**CU24-04 312 Opportunity Parkway., Progress Park Subdivision Block “C”, ANS Properties, LLC, Applicant, -** requests a Conditional Use approval for a hotel with conference center, zoned BP Business Park, 3.9 acres +/-

**EXHIBITS:**

Site plan file dated October 7, 2024  
 Building Plans file dated October 7, 2024  
 Site Lighting Plan file dated October 7, 2024  
 Statement of Intent file dated October 7, 2024

# Site Lighting for Greenfield In Hotel

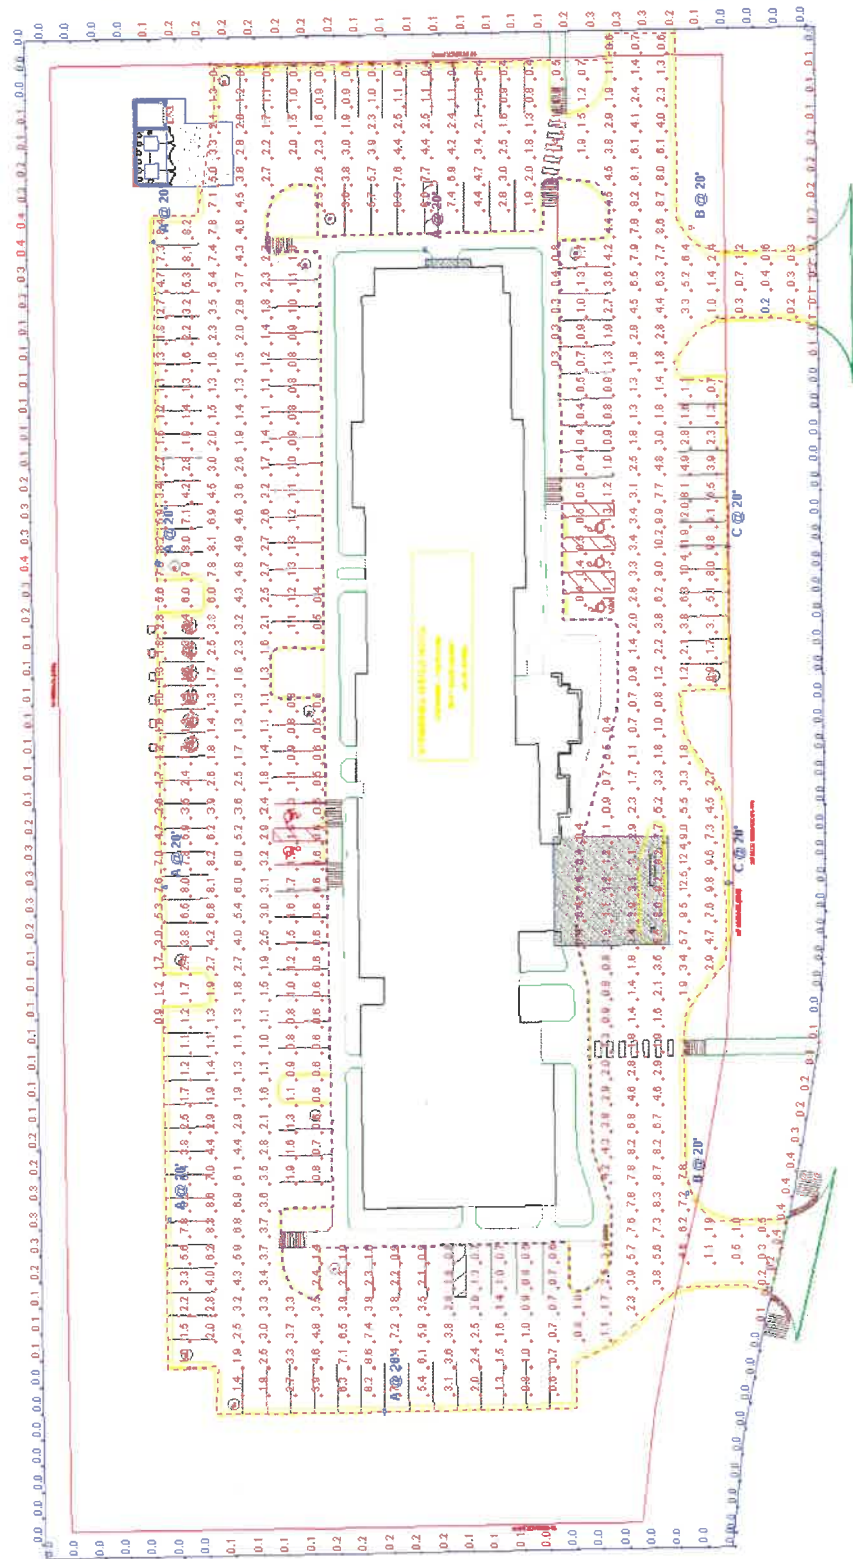
**(e) Signs and proposed exterior lighting with reference to glare, traffic safety, economic effect, and compatibility and harmony with properties in the district.**

**Findings:** A sign plan was not included in the application but will need to meet the requirements of the UDO for size and location as to be compatible with surrounding uses.

**SHEET C3.1**

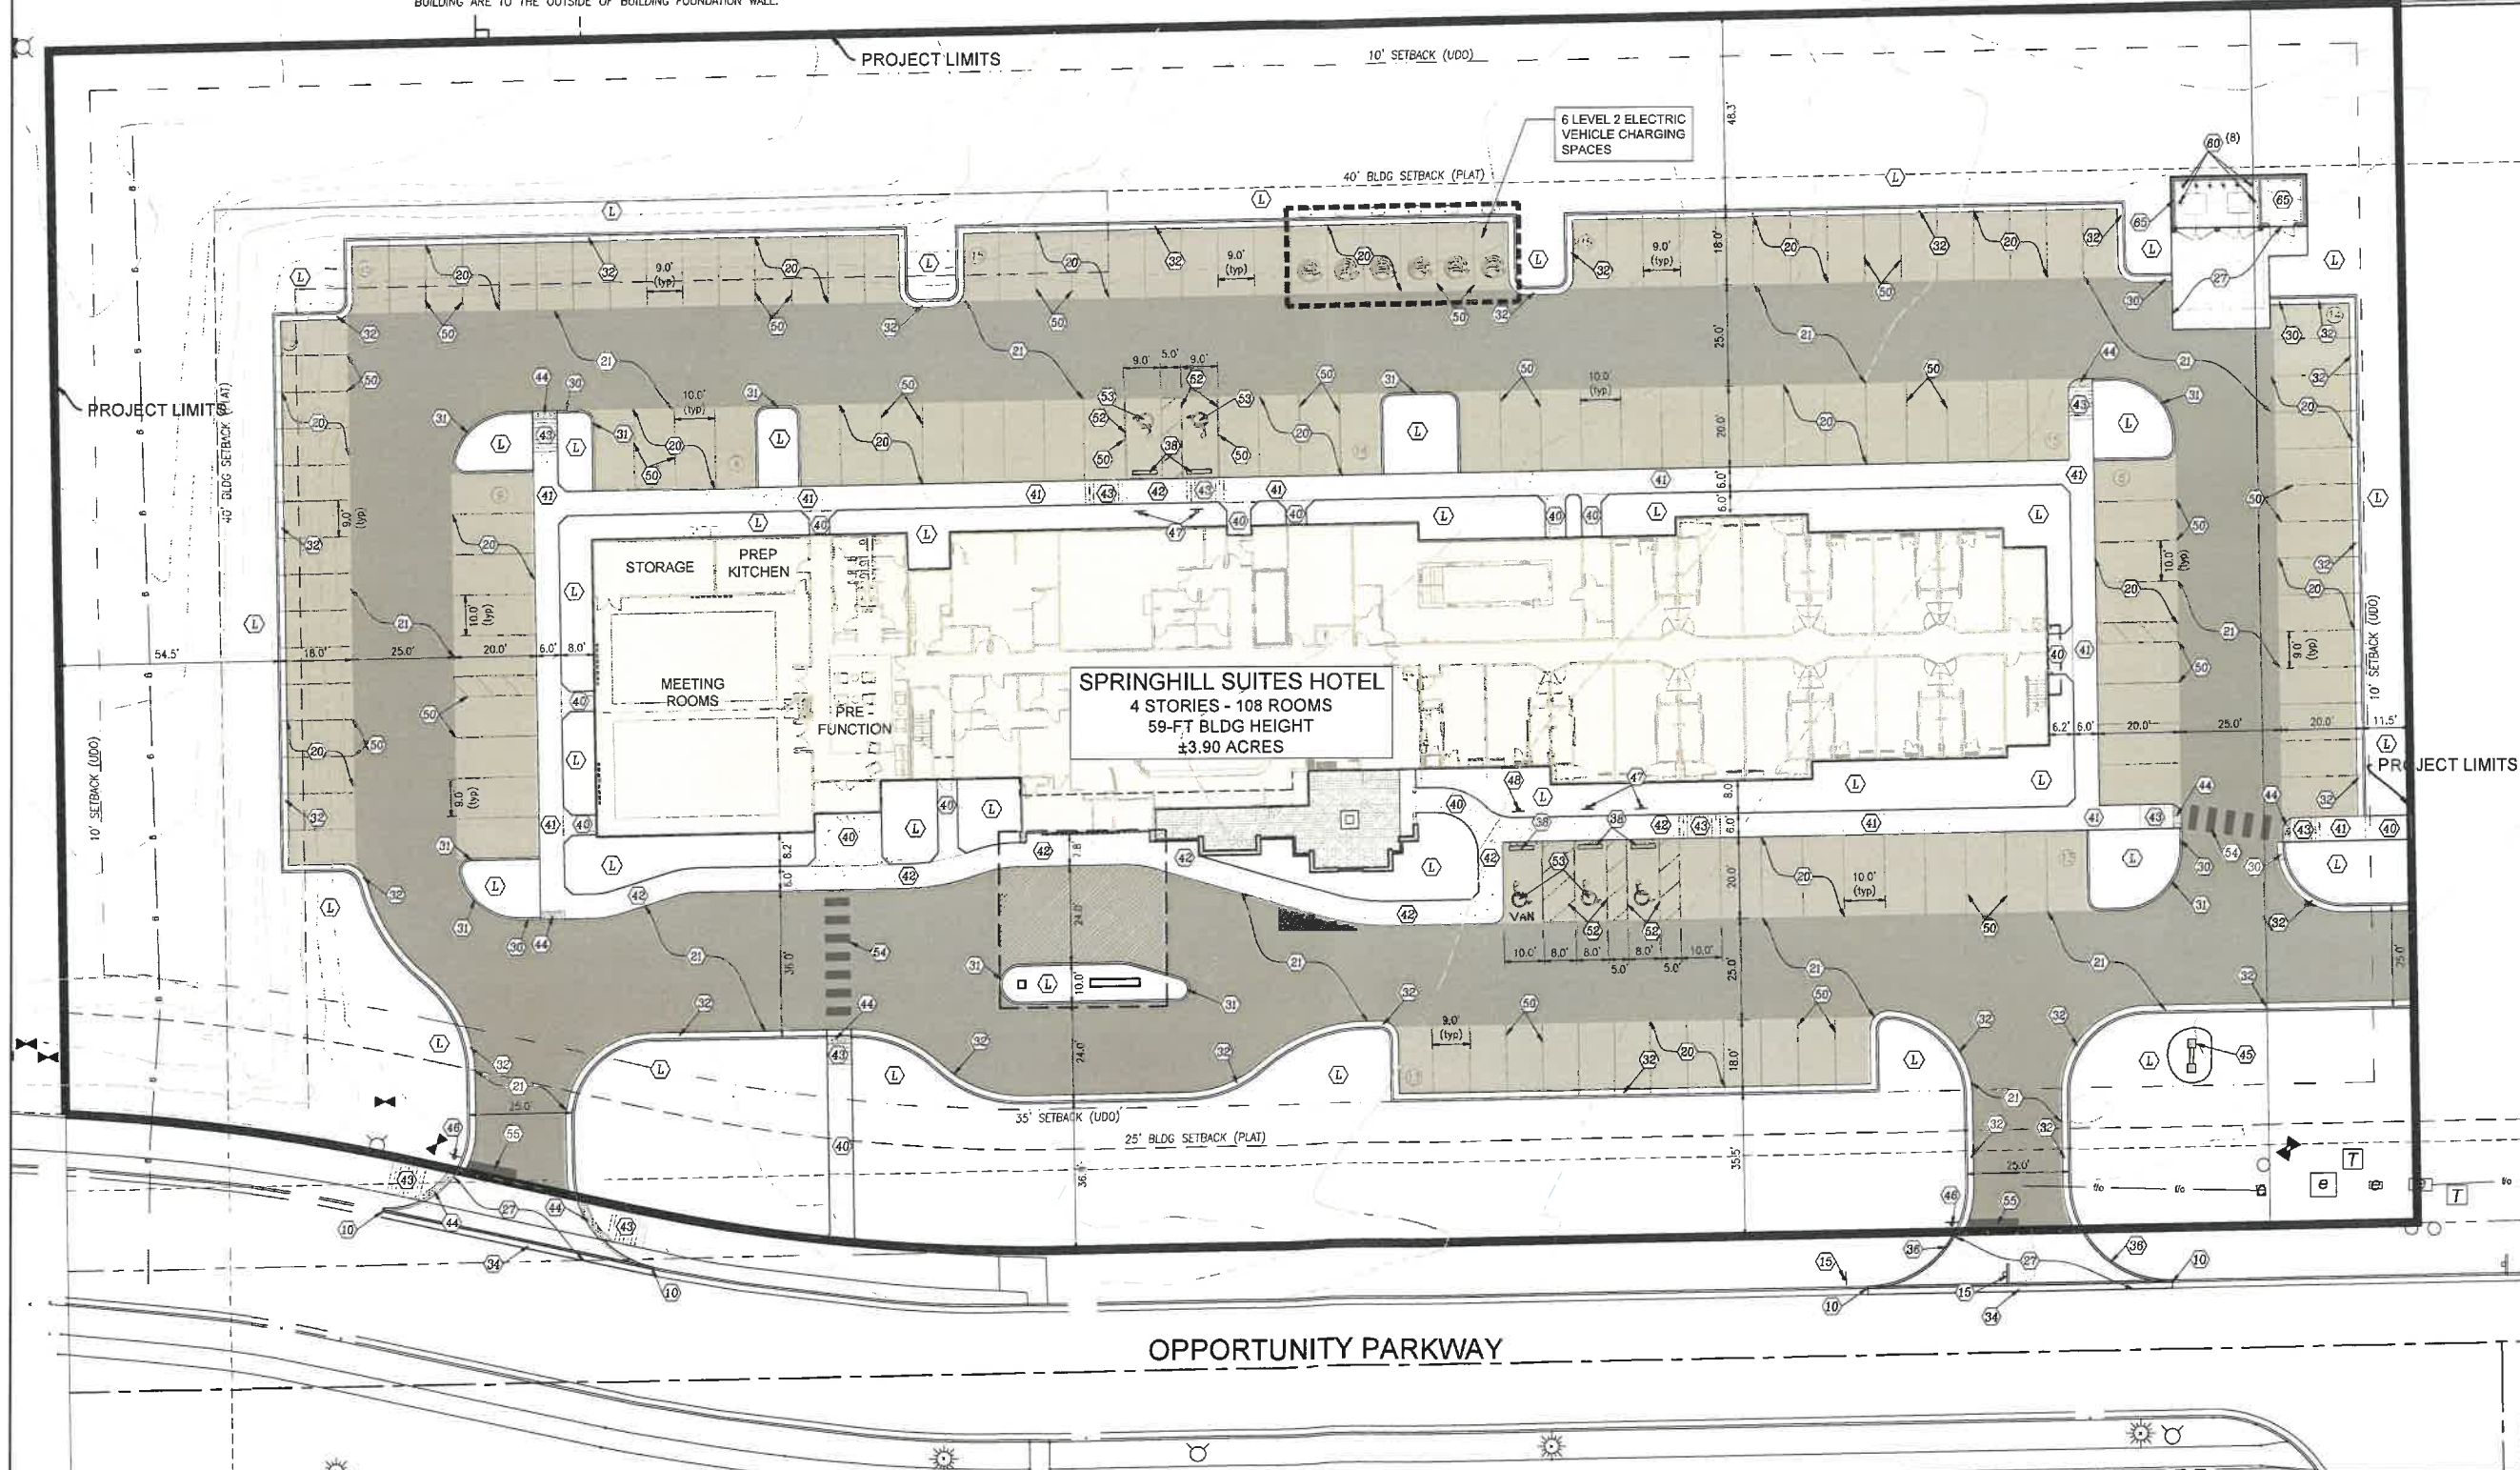
**Findings:** The petitioner proposes to improve the site with 150 parking spaces with five of those being handicap spaces and six electric vehicle parking. The handicap spaces are divided between the front and back of the building. The total number of spaces needed per the UDO is 135 with an overage not to exceed 150 percent of the required spaces. The proposed 150 spaces meet the requirements of the UDO. The petitioner has submitted a parking lot lighting plan that shows zero-foot candles at the property lines. The parking lot will also be landscaped per the requirements of the UDO. Staff finds that the proposed parking and loading areas on the site are like other permitted uses in the business park district, however staff does not find semi-truck parking compatible.

**Findings:** The refuse area is proposed on the northeast corner of the site and is proposed to be enclosed in an opaque screen with gate. Staff finds that this location is logical as it allows easy access for the trash trucks and is not located on the front of the site. This style of refuse area is common in the business park district.

1. No semi-truck parking on the lot.
2. Necessary development plan approval is obtained.
3. All necessary Construction Design Releases and Improvement Location Permits be obtained.
4. Signs shall meet the requirements of the UDO and sign permits obtained.
